**PLANNING AND ACCESS COMMITTEE**

<b>SUBMITTED BY:</b>	Head of Planning & Rural Development
<b>APPLICATION NUMBER:</b>	2016/0042/DET
<b>APPLICANT:</b>	MacIntosh Homes Ltd.
<b>LOCATION:</b>	Site of Former Finnartmore Nursing Home, Kilmun PA23 8RY
<b>PROPOSAL:</b>	Erection of flatted block comprising 8 affordable units. Modification of planning condition no.13 of permission ref: 2011/0288/DET to revise the number of parking spaces within the flatted development, to provide 12 spaces.

## Agenda Item 5

**Figure 2. Site Plan - Revised Parking Layout**

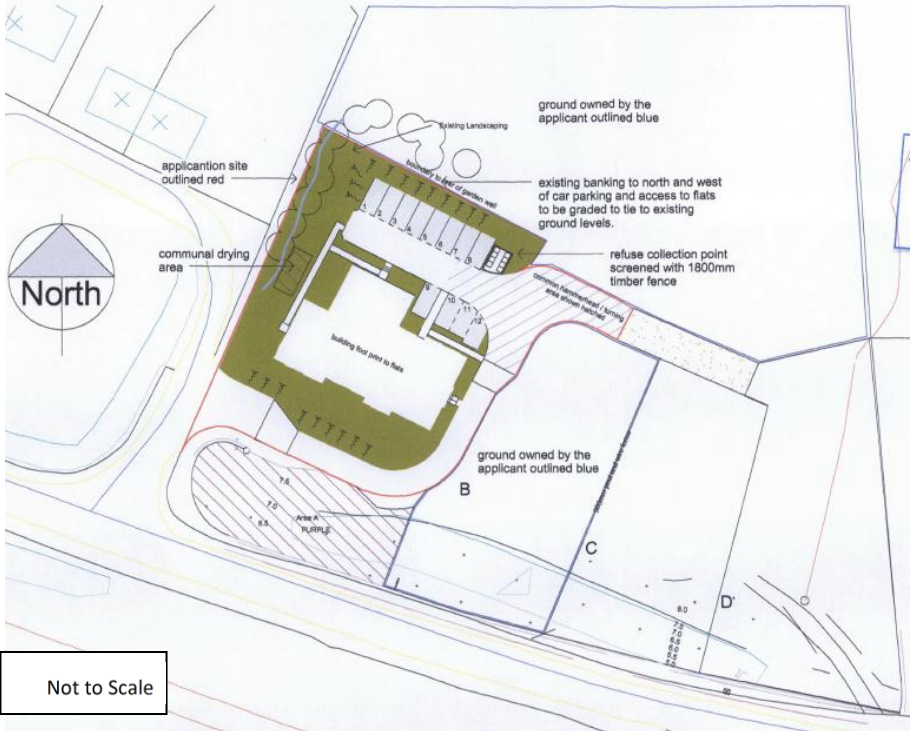
- The current plan (dwg. no. D260b) differs from the layout previously approved for the 8 flats and for plots 1 & 2 and shows the 'passing place' in a different location. Advice taken from the aforementioned Police Officer is that the access road, as constructed, is not suitable for refuse vehicles, fire appliances, construction vehicles or normal HGV delivery vehicles. It is therefore requested that the road layout, specifically the passing space, is altered to that shown on the original approved design.

- The current refuse point shows 8 spaces. Space for 16 refuse bins should be provided to meet the Argyll & Bute Council requirement for 2 bins per dwelling.

- Parking space nos.11 and 12 are compromised in length, with the possibility that parked vehicles will encroach on the road splay.
- The manoeuvring space in front of the parking spaces appears to be 5m rather than the normal 6 metre minimum.

- The existing boundary fence around Plot 1 restricts vehicles from negotiating the bend and requests an inspection to resolve this issue.
- The expanse of tarmac is unsympathetic to the character of the rural area.
- Questions raised regarding what provision is in place to manage surface water run-off to avoid further water run-off via the new road surface.

8.10 Representations from the Kilmun Community Council and neighbouring residents raise concern that the design of the access, the radii of the bend with adjacent passing place, the manoeuvring space, and the presence of fencing along the boundary of Plot 1 have, and will result in an obstruction to the free passage of larger vehicles. Furthermore they state that any overspill parking onto the access would further exacerbate this potential issue. In addition, the contributors request that the road layout and passing place location be amended to match that previously approved (planning permission ref: 2011/0288/DET).

- Parking requirements have been assessed on the basis of the Council's Road Development Guidelines for differing tenures of housing. On this basis the advice provided is that, for a development of 8 flats, the maximum number of spaces required for combined resident/visitor parking would be a total of 11 spaces.
- The development of 8 units provides 12 parking spaces.

- The access serving the development has a 3.7m wide running surface with passing places.
- 'Swept path analysis' drawings indicate that this access route will be suitable for both Emergency and Service vehicles.

8.11 The Roads Authority has considered the new alignment and design and has confirmed that the width of the access is acceptable and that the submitted 'Swept Path Analysis' drawings demonstrate that the layout is acceptable for larger service vehicles. As such, the Roads Authority has no objection to the amended road layout as submitted and formed on-site.

- 8.15 In conclusion, it is considered that there is no justifiable reason for the planning authority to require a change to the new road layout or design, given that this is deemed acceptable to the Roads Authority and therefore accords with the relevant development plan policy. As such, it is recommended that the road layout for the flatted development be approved on the basis of the details shown on the submitted drawing no. D260(b). It is considered that there is no requirement for a planning condition to address this matter in any new decision notice issued.
